Restoration, Acquisition, and Combination Project Proposal

Project Number	15-1198 RST
Project Name	Moga Back-Channel Construction
Sponsor	Snohomish Conservation District

RCO Review Panel Comments

1.

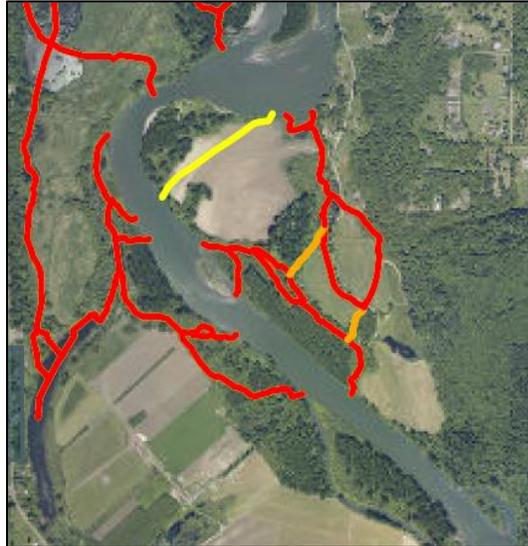
- What is the probability of outlet blockage by deposition from the main river, particularly given that the geomorphic report (Snohomish County, 2015) predicts that the downstream segment (“16+17” by their terminology) is shown as “Moderate Aggradation” on their *Plate 3 - Snohomish River Bed Stability Rating*?

Airphoto inspection and our field visit both show that the outlet location is at a zone of persistent scour at moderate and high flows, lying at the outside of a prominent bend. Although at a whole-river scale this does appear to be a zone where some deposition occurs (Snohomish County, 2015), the local hydraulics are not well-represented by the coarse granularity of the R2 sediment-transport modeling. The outlet should remain well-scoured of potential sediment accumulations indefinitely into the future.

Aerial view of the project site, showing its location relative to the outside bend of the Snohomish River where scour is ubiquitous (flow from left to upper right).

Sequential views of the primary pond at the project site in 1990 (left) and 2015 (right), showing no obvious effects of sedimentation in the intervening 25 years.

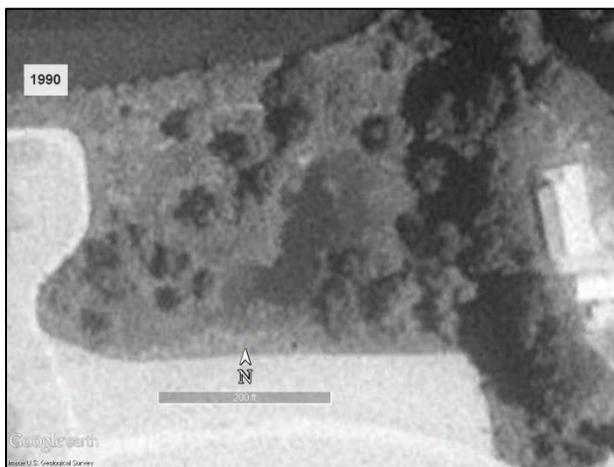
- What is the likelihood that overbank flows will deposit fine sediment into the excavated channels and pond complex, resulting in the long-term loss of these habitat features?

The hydraulic modeling suggests that the relict channels are inundated by 2- to 5-year discharges, and so the most obvious conclusion is that the ponds in their current configuration (which includes relatively poor outlet passage for floodwaters) have managed to persist for at least the last several decades with no systematic changes in size/appearance resulting from sedimentation. This is likely a consequence of the shortened flow path that floodwaters can take across the bar, relative to the longer path around the bar at lower flows, resulting in locally steeper hydraulic gradients and thus a potentially enhanced ability to transport suspended sediment.

Project site, showing flow paths activated at 2-year (red), 5-year (orange), and 10-year (yellow) discharges. The flow path that is connected fully across the bar at 5-year and higher discharges which includes the path of the proposed channels at its downstream end. The side channel is roughly $\frac{1}{2}$ the length of the main channel, suggesting that the gradients are likely twice as steep as in the main channel and are likely to have significant sediment-transport capacity under moderate and larger floods.

Persistence of the pond feature on the project site, observed over at least the last 25 years, is likely to be enhanced following project implementation, insofar as the excavation of the planned outlet channel should enhance downstream flow (and thus sediment transport) back out to the

Snohomish River. No quantitative modeling of this condition appears to be necessary on the basis of both the empirical history and the nature of the proposed actions.
